Minor Amendment to Site Plan - EPC for adjustments in response to soil and drainage conditions, accessibility requirements, and reviewer comments at building permit.

RE: Andalucía Senior Housing Site Plan and Related Applications

The purpose of this letter is to request approval of a Minor Amendment to the Overture at Andalucia Site Plan – EPC based on changed conditions and design changes necessitated during development of the building permit drawings due to platting, accessibility, and soil conditions. The subject site is legally described as Tract 4, Plat of North Andalucia at La Luz containing approximately 7.7 acres and is located at 5301 Antequera Road NW.

**Overture Andalusia Senior Housing
PROPOSED NAME OFSITE DEVELOPMENT PLAN**

2 SIDE ELEVATION
3/16"=1'-0"

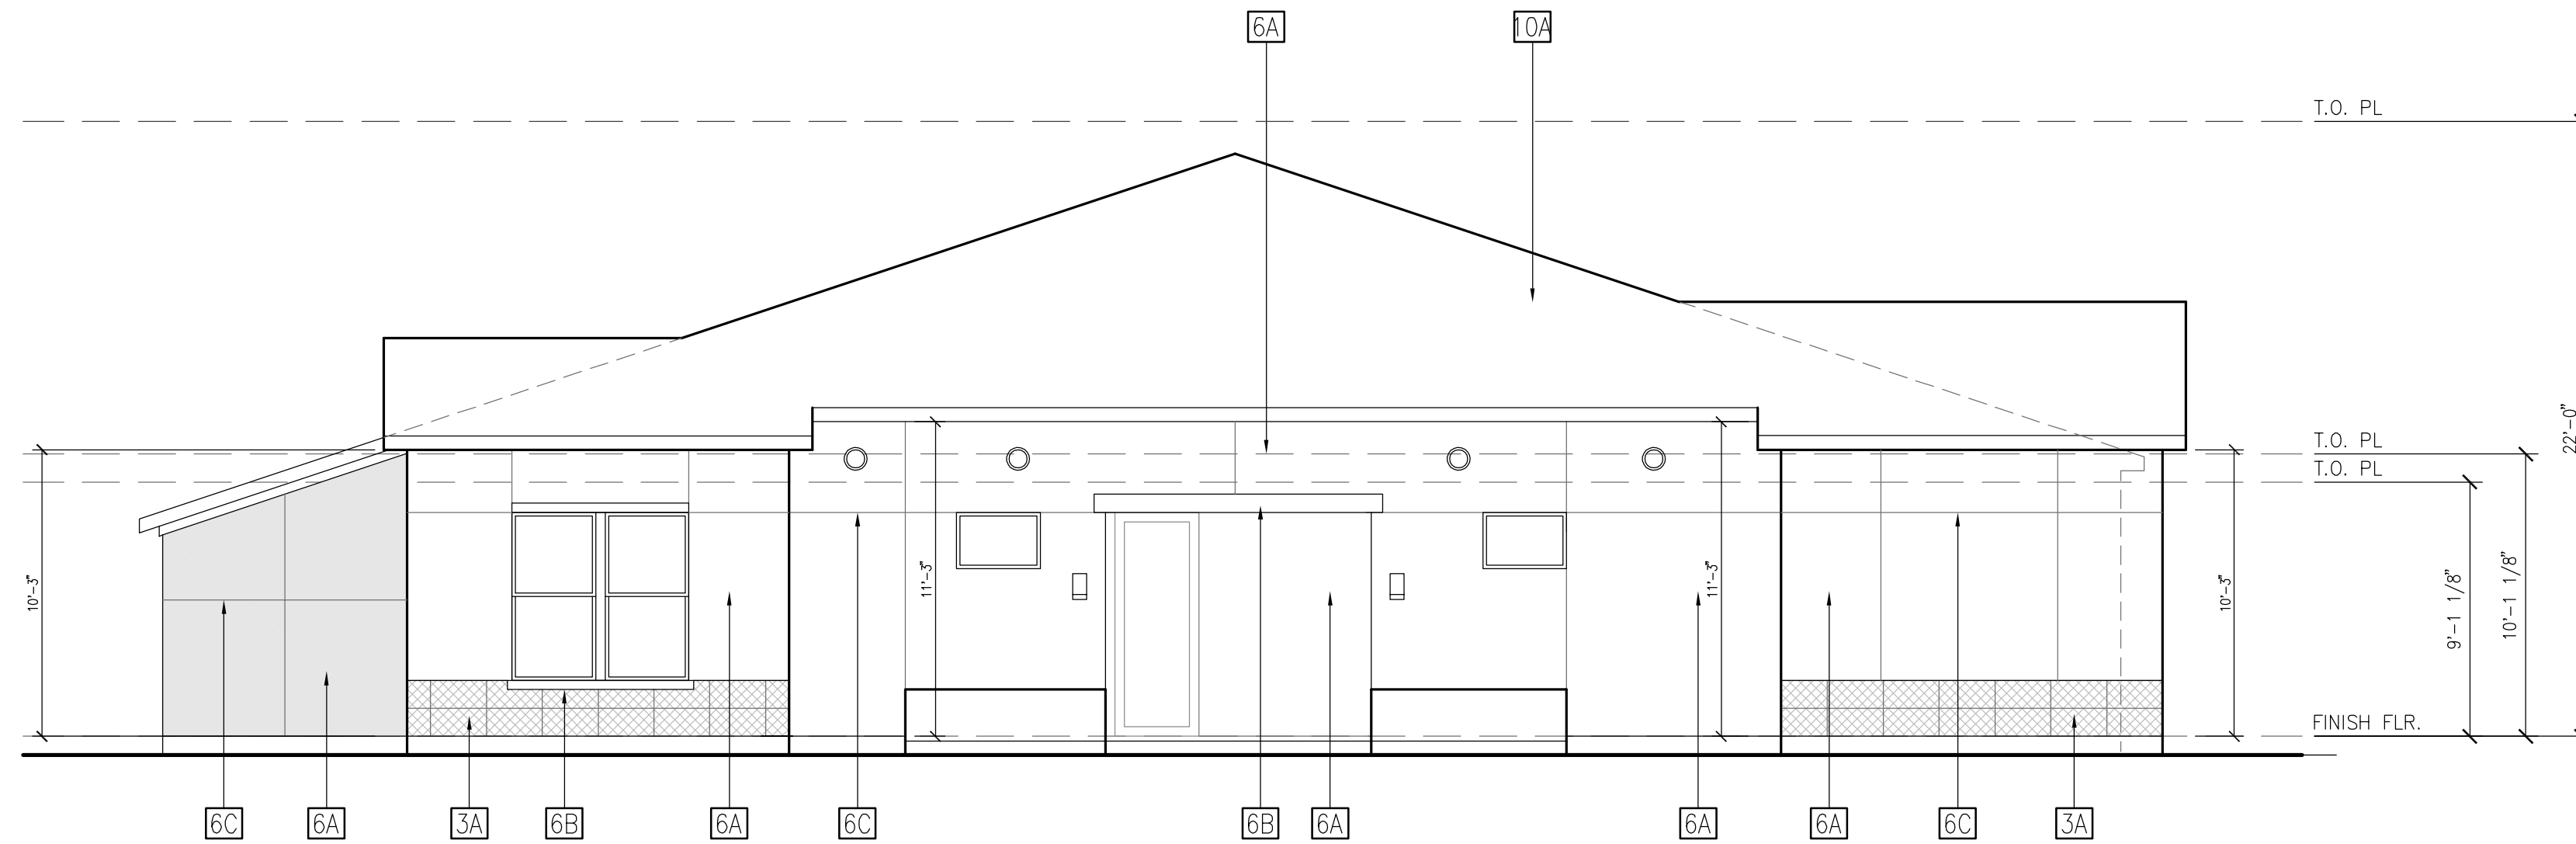
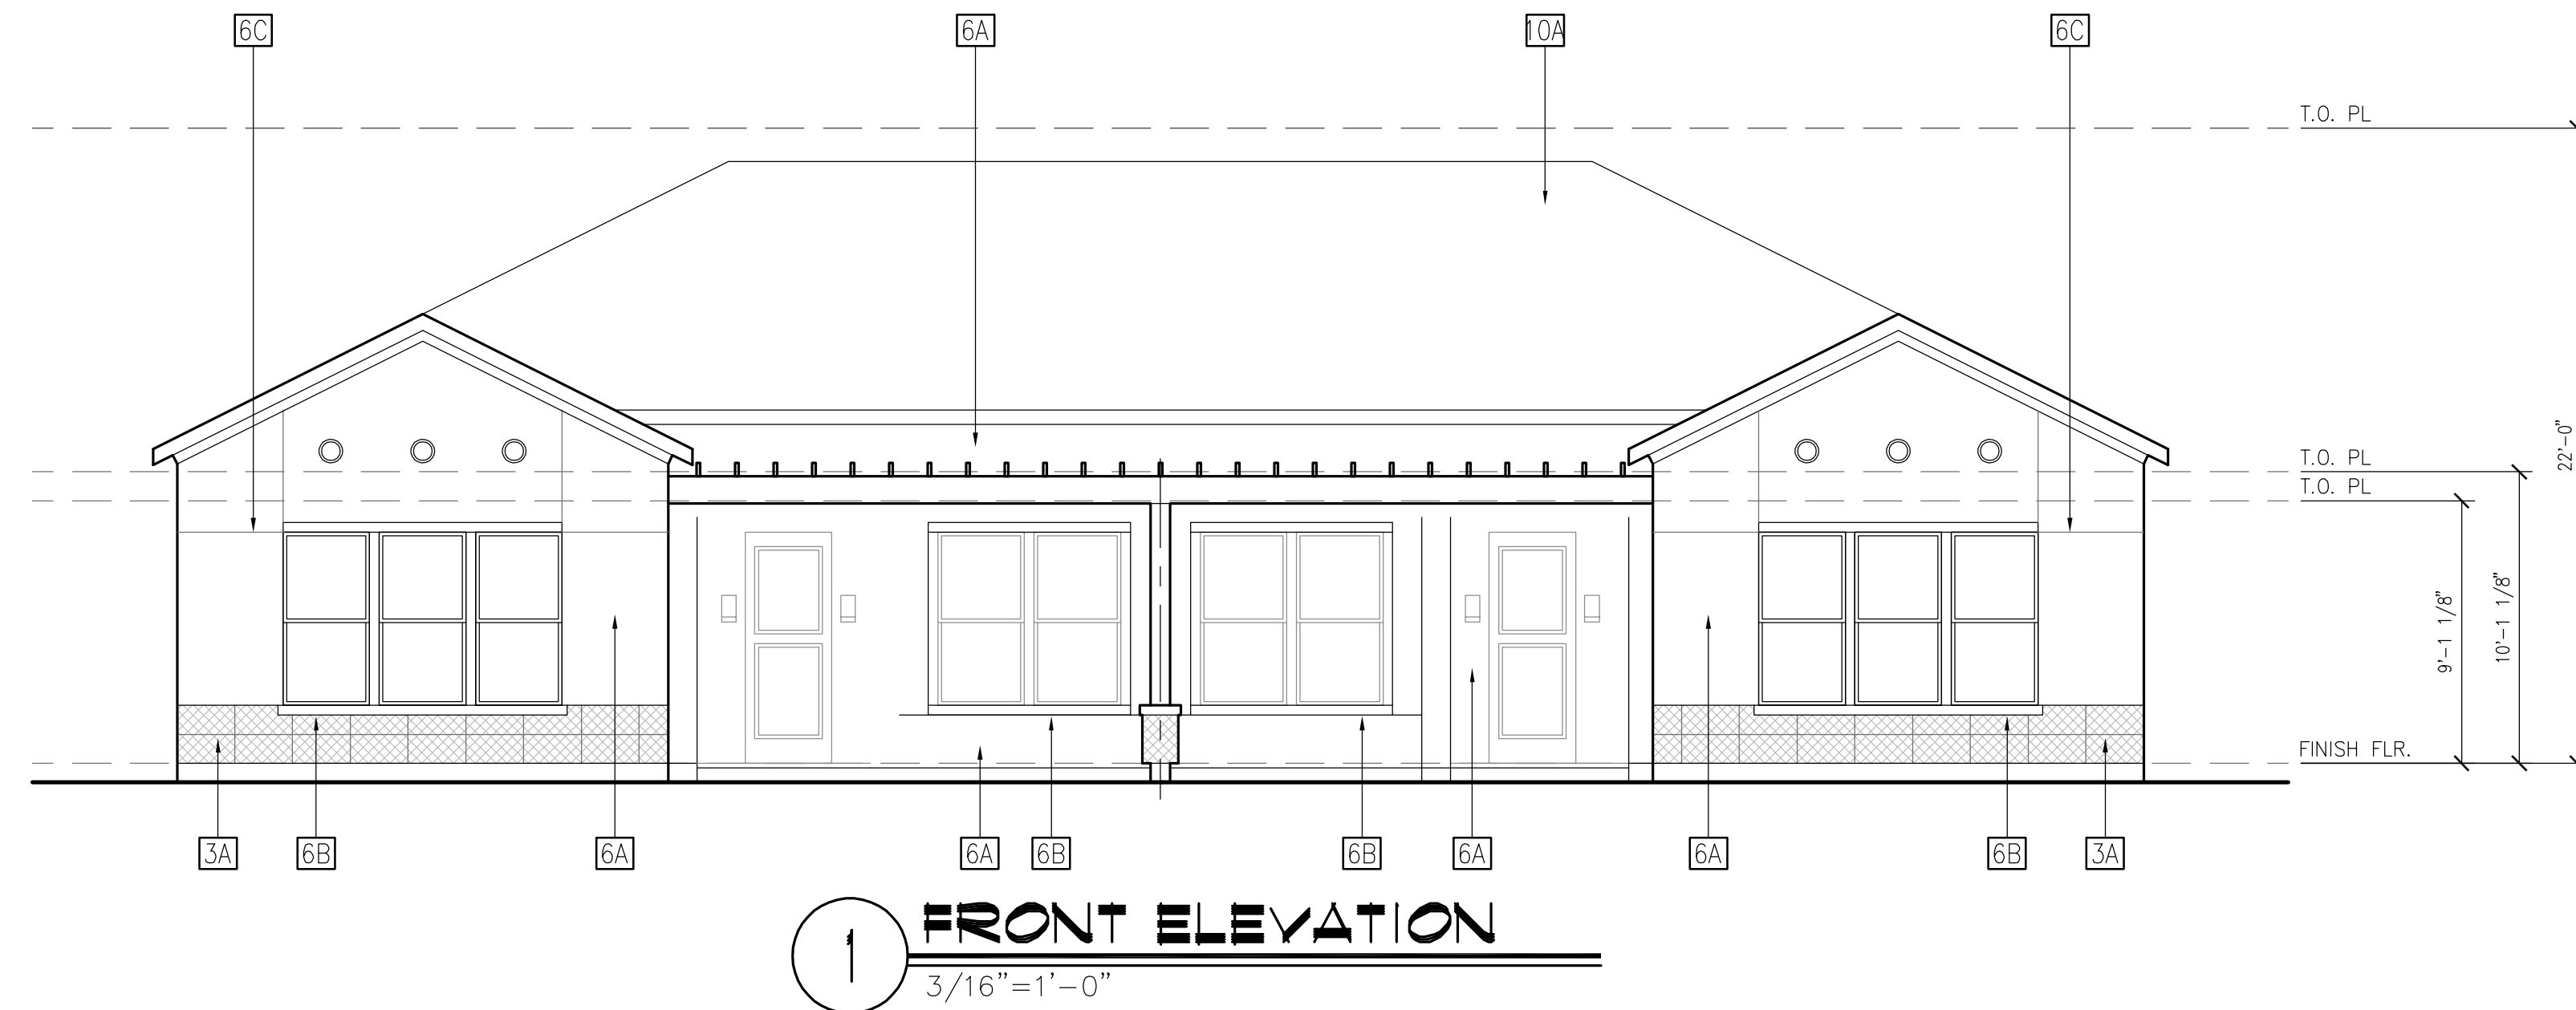
4. The building elevations for the cottage duplex units were updated to remove a thin stone veneer from the base of the exterior walls, which provides for a cleaner design that better matches the larger primary building design as viewed from the surrounding streets. Minor modifications to windows and awning were made to the primary building to accommodate roof drainage requirements with downspouts.

The proposed amendment removes a thin stone veneer from the base of the duplex cottage units, which will match most of the larger building with a cleaner stucco finish. By switching away from the veneer, the durability of these facades will be improved with easier maintenance that will ensure the perception of building quality from the adjacent streets remains over time. The minor modifications to windows and awnings were made to accommodate drainage downspouts from the roof of the primary building. The changes to the street-facing façade along Antequera (east) were only to relocate awnings to another location on the same façade, so the overall quality of design and articulation is unchanged when viewed from the street and adjacent multi-family development.
